APPLICATION FOR IMPROVEMENT PERMIT
FOR RESIDENTIAL SITE
INDIVIDUAL WATER AND WASTEWATER
SYSTEMS PROGRAM

SOIL/SITE EVALUATION for ON-SITE WASTEWATER SYSTEM

Re: Application for improvement permit for Richard Hagemeyer
Property Site: lot 10, Kalabash Road
Health Department file no. 4871B

Re: Detailed Soil/Site Evaluation on a ±10.0acre site (Lots 1 – 10) on the corner of Harbor View and Kalabash Roads, Mecklenburg County, NC.

SHEET 1 OF 1	SHEET TITLE: DETAILED SOILS EVALUATION	PROJECT NAME: R.H. HEGEMEYER, INC. - HARBOR VIEW - MECK. COUNTY, NORTH CAROLINA MAY 2002	S&EC Soil & Environmental Consultants, PA

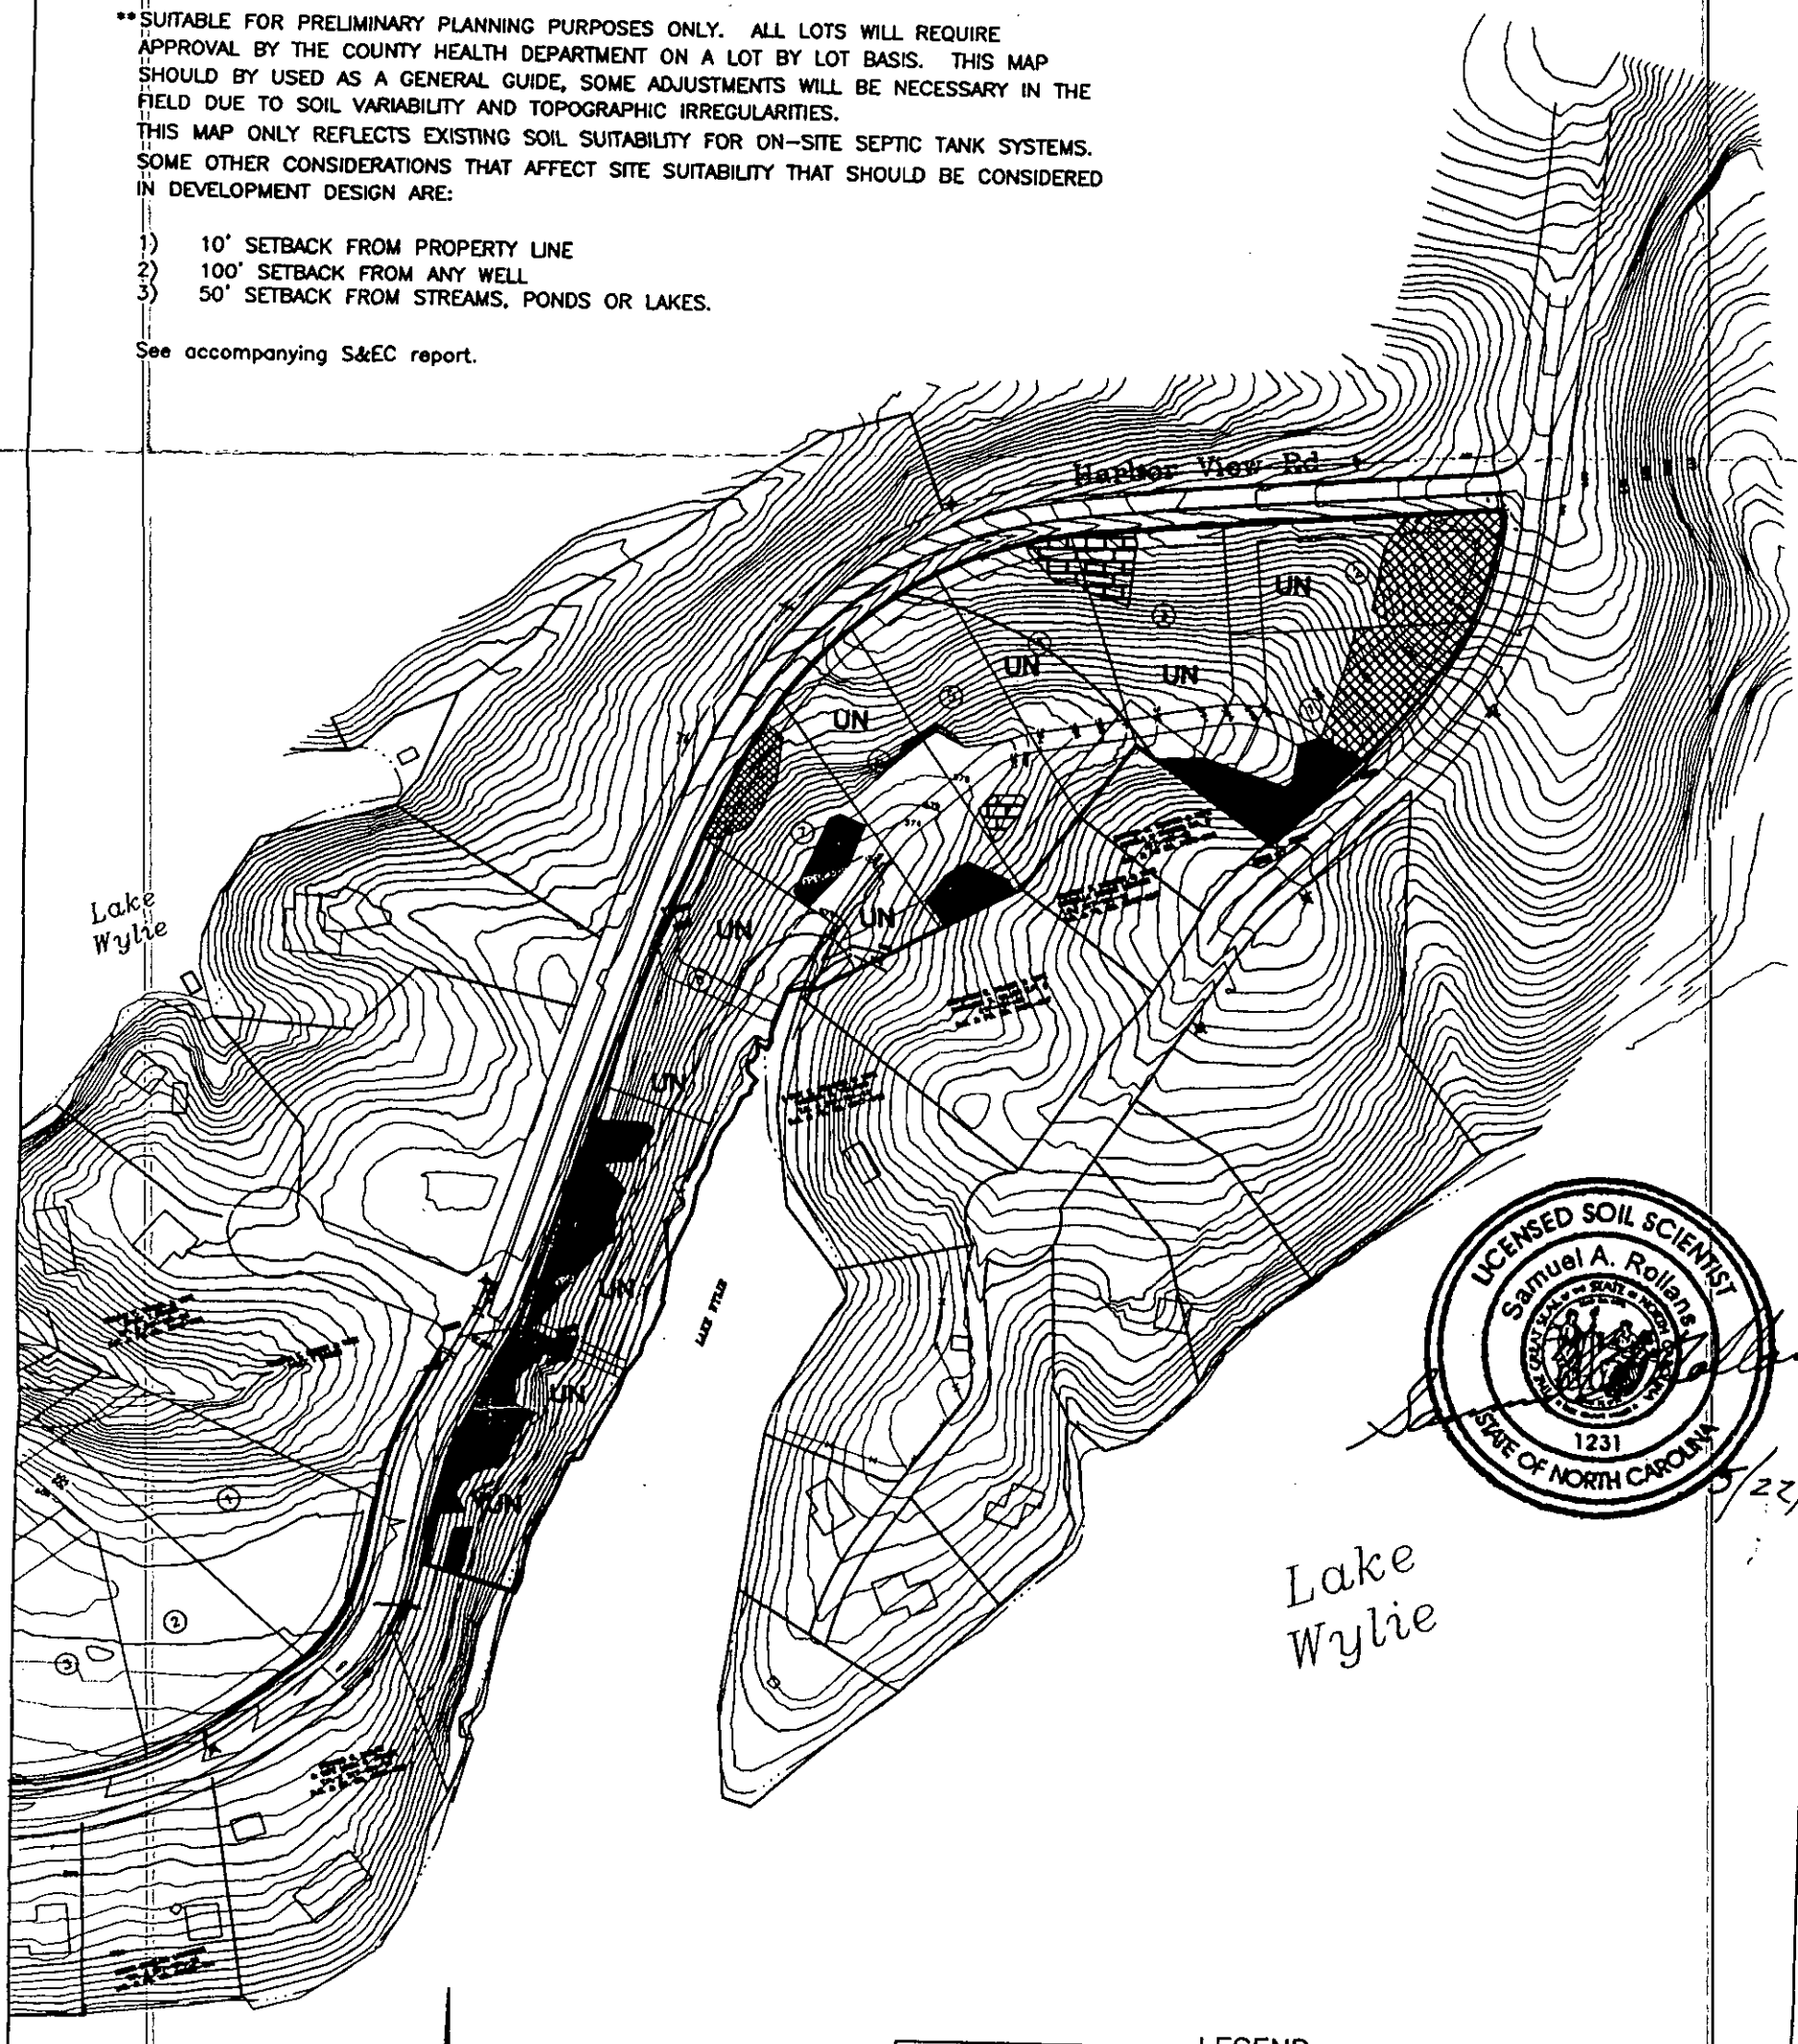
The accompanying *GPS/AutoCAD* map indicates the areas with potential use for subsurface wastewater disposal. The **"Solid-Hatched"** units indicate areas of soils that are at least 30 inches deep to prohibitive soil characteristics and have potential for conventional and modified conventional (shallow placed lines with no fill required over the disposal area) septic systems. The **"Diamond-Hatched"** units indicate areas of soils that are 24 to 30 inches deep to prohibitive soil characteristics and have potential for low pressure pipe system (LPP) and/or ultra-shallow conventional (shallow placed lines with fill required over the disposal field) system. The **"Block-Hatched"** units indicate areas of soils that are 18 to 24 inches deep to prohibitive soil characteristics and have potential for subsurface drip irrigation w/pretreatment septic systems. Such systems typically cost in excess of $15,000.00 to $20,000.00 +. The **"UN"** units on the attached map indicate soil areas with less than 24 inches to unsuitable characteristics and generally unsuitable for systems mentioned above.

** SUITABLE FOR PRELIMINARY PLANNING PURPOSES ONLY. ALL LOTS WILL REQUIRE APPROVAL BY THE COUNTY HEALTH DEPARTMENT ON A LOT BY LOT BASIS. THIS MAP SHOULD BY USED AS A GENERAL GUIDE, SOME ADJUSTMENTS WILL BE NECESSARY IN THE FIELD DUE TO SOIL VARIABILITY AND TOPOGRAPHIC IRREGULARITIES.
THIS MAP ONLY REFLECTS EXISTING SOIL SUITABILITY FOR ON-SITE SEPTIC TANK SYSTEMS. SOME OTHER CONSIDERATIONS THAT AFFECT SITE SUITABILITY THAT SHOULD BE CONSIDERED IN DEVELOPMENT DESIGN ARE:

1) 10' SETBACK FROM PROPERTY LINE
2) 100' SETBACK FROM ANY WELL
3) 50' SETBACK FROM STREAMS, PONDS OR LAKES.
